Hydrol. Earth Syst. Sci. Discuss., referee comment RC1
<https://doi.org/10.5194/hess-2022-199-RC1>, 2022
© Author(s) 2022. This work is distributed under
the Creative Commons Attribution 4.0 License.

Comment on hess-2022-199

Referee comment on "Regional significance of historical trends and step changes in Australian streamflow" by Gnanathikkam Amirthanathan et al., Hydrol. Earth Syst. Sci. Discuss., <https://doi.org/10.5194/hess-2022-199-RC1>, 2022

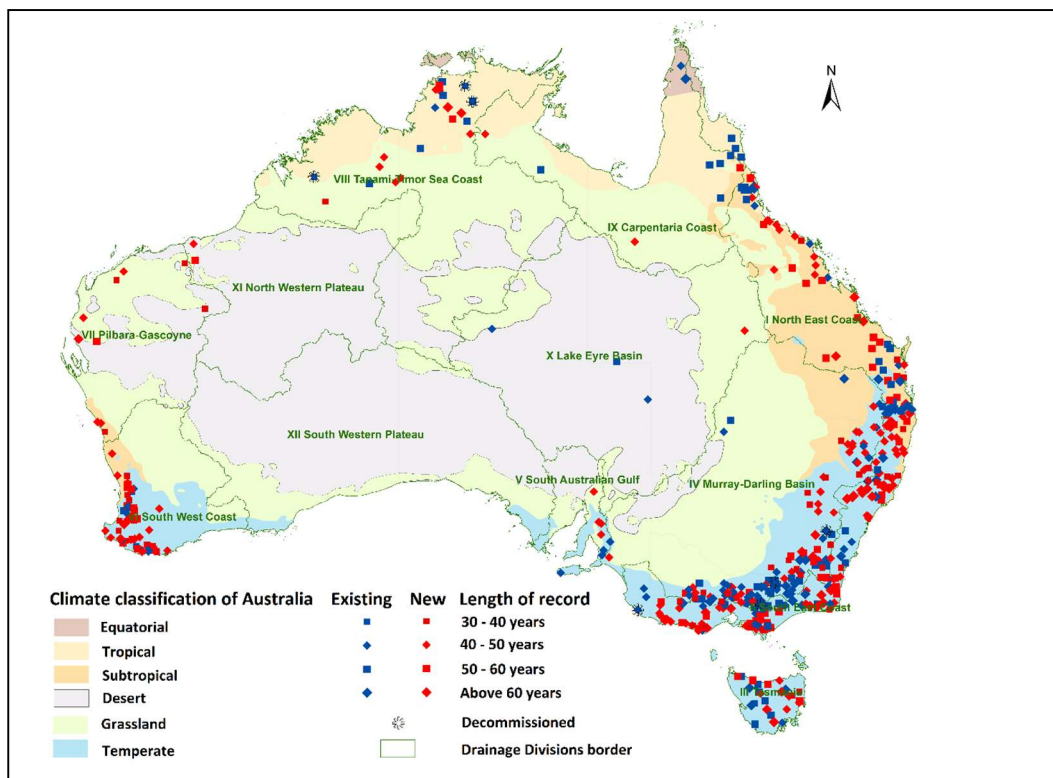
Reviewer comment: Figure 1, north arrow is missing

Author Response: Apology of the omission, it is now fixed, please see below. The updated figure will be included in the manuscript.
